## **ADDENDUM 1**

Project: NMHS Restroom Remodel

Date: July 16, 2024

Invitation for Bid No.: 24-01-03

**G1.01**

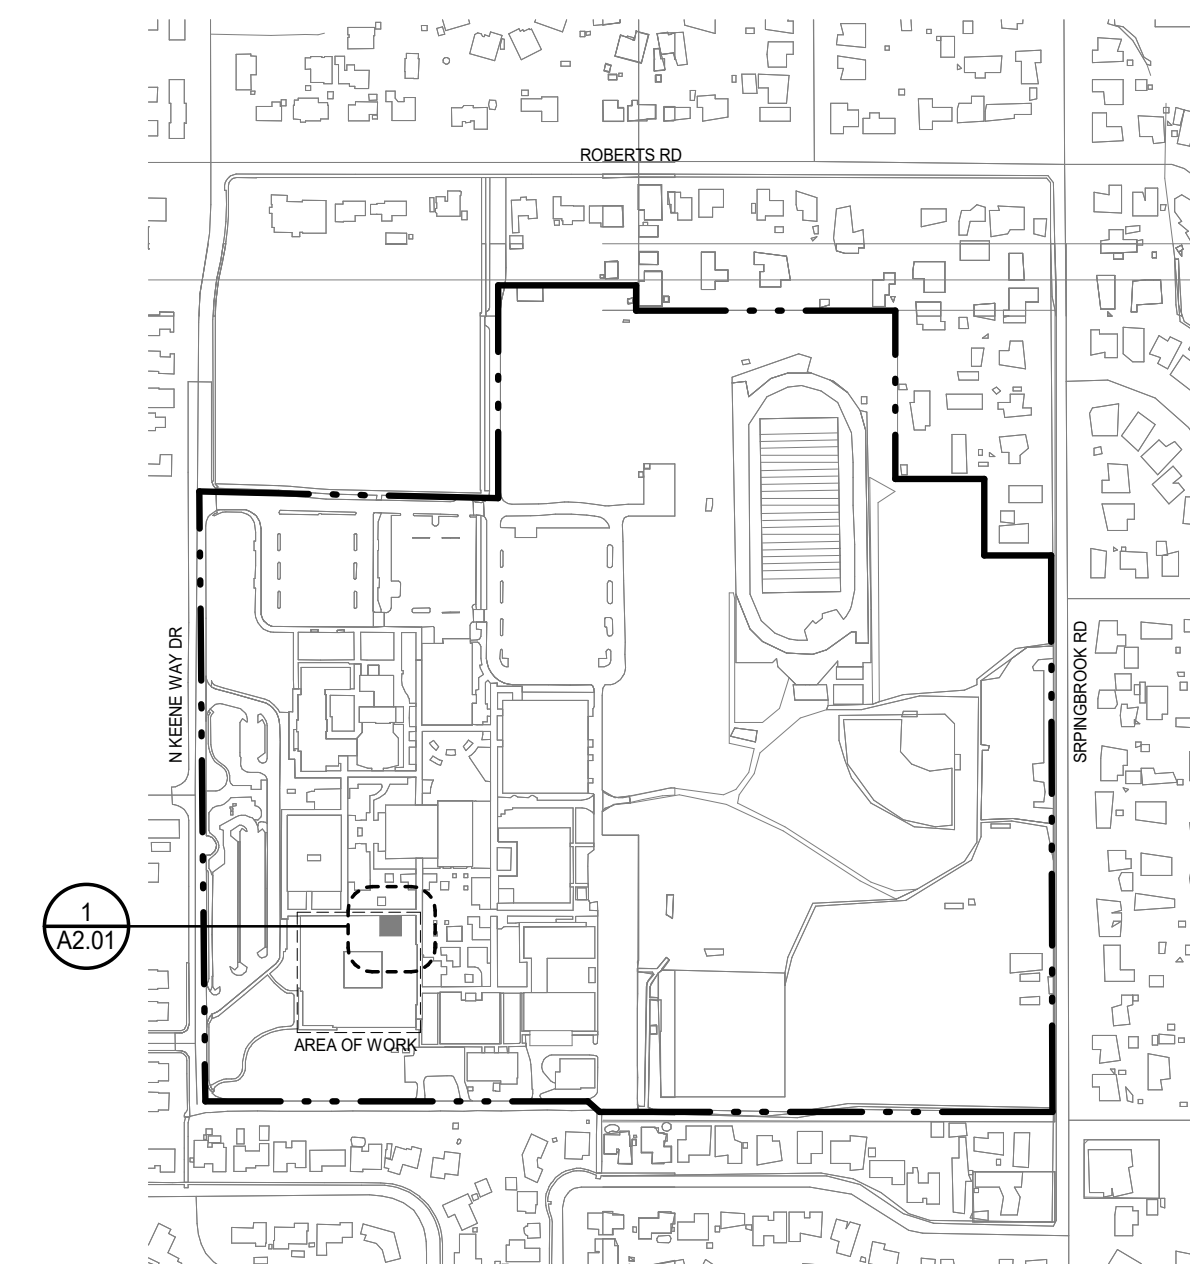
2. G1.01 - PROJECT INFO
  - a. sheet index updated with a new sheet and edited sheet name
  - b. relocated plumbing calculations to a different sheet
3. G3.02 - CODE ANALYSIS
  - a. new sheet added to set
4. A2.01 - FLOOR PLAN
  - a. updated door swings
  - b. shift of sinks to accommodate door swings
5. A8.01 - EXTERIOR AND INTERIOR ASSEMBLIES
  - a. update to partition type
6. A9.01 - FLOOR PLAN
  - a. updated door hardware sets
